EMU Master Plan Change 2014

1200 Park Road TM 51-A-1

STAFF REPORT September 10, 2014

REZONING – EASTERN MENNONITE UNIVERSITY MASTER PLAN CHANGE 2014

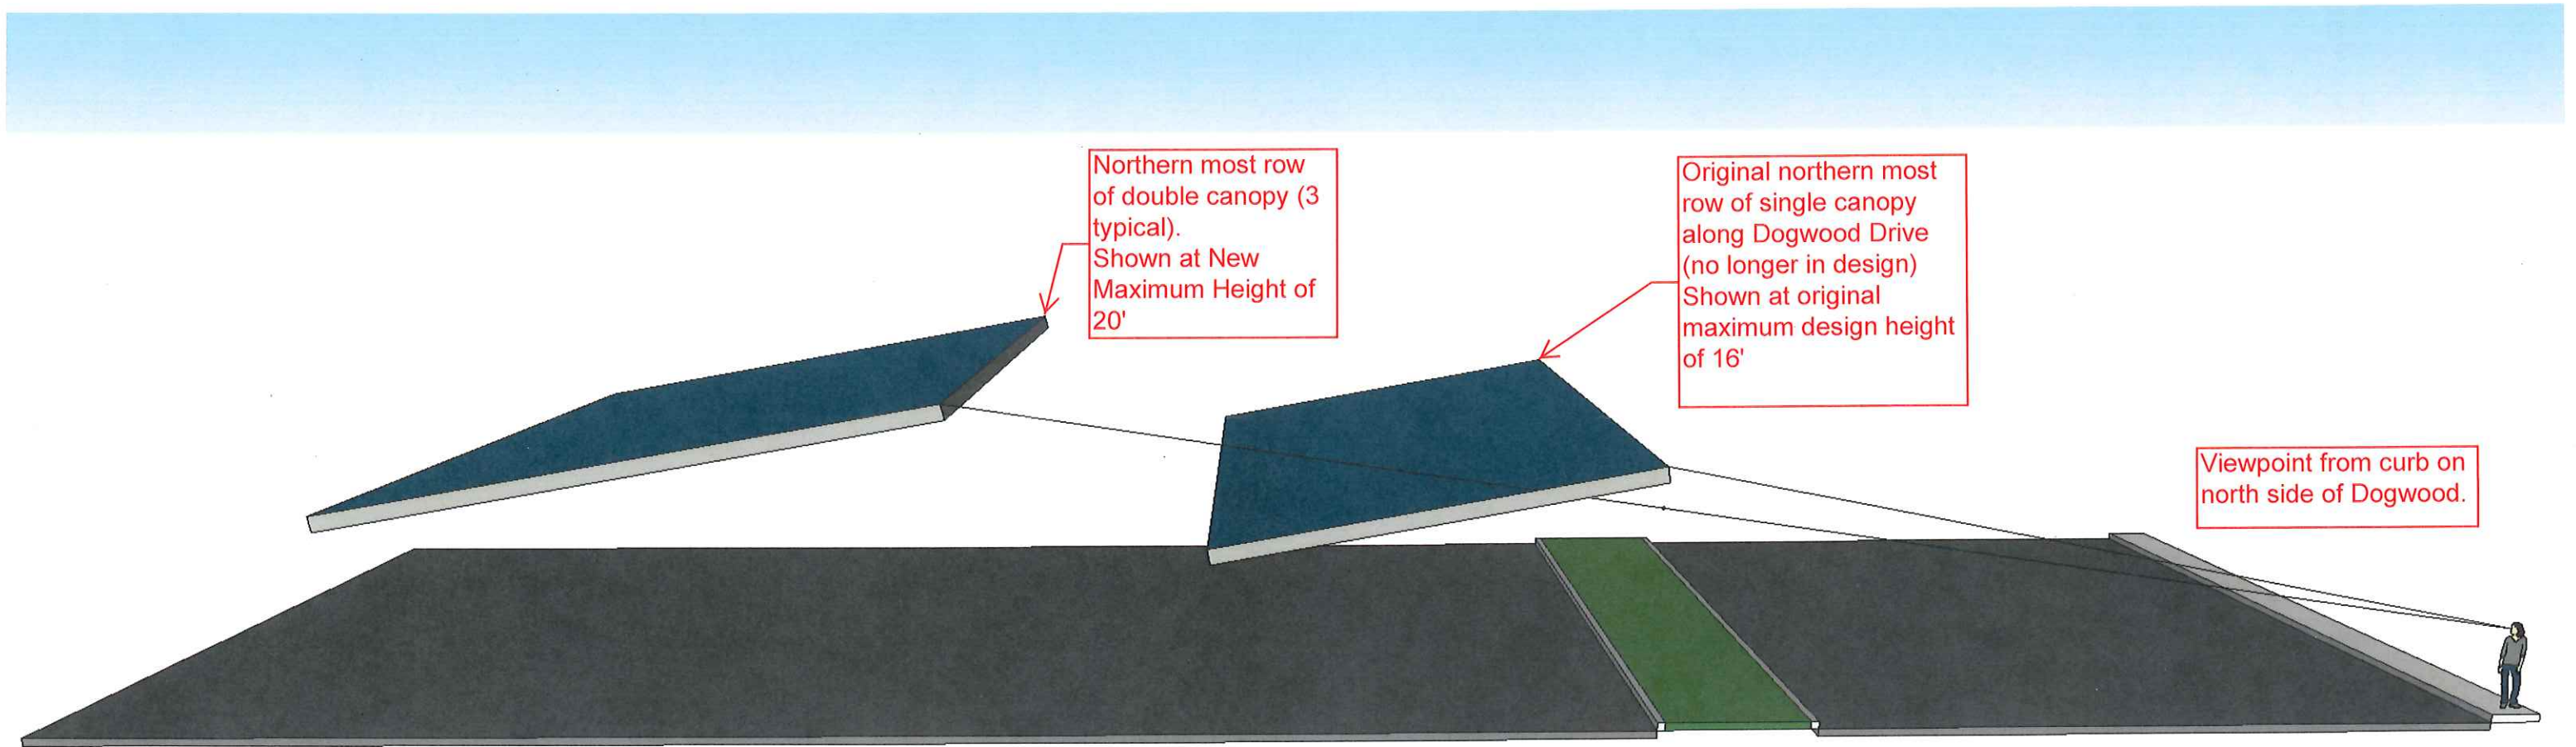
Note: The proposed single width canopy structure adjacent to Dogwood Drive has been removed from consideration. The array will consist of three identical double width canopy structures. Removing the canopy adjacent to Dogwood from the plan, will allow the visual impact on Dogwood Drive property owners to be reduced by 2' 8" despite the increased height. See attached schematic.

By eliminating the northern most single row, the visual impact to residences along Dogwood Drive is reduced by 2'-8", despite an increase in maximum design height to 20'. The minimum design height remains at 8'-6" for clearance and safety.
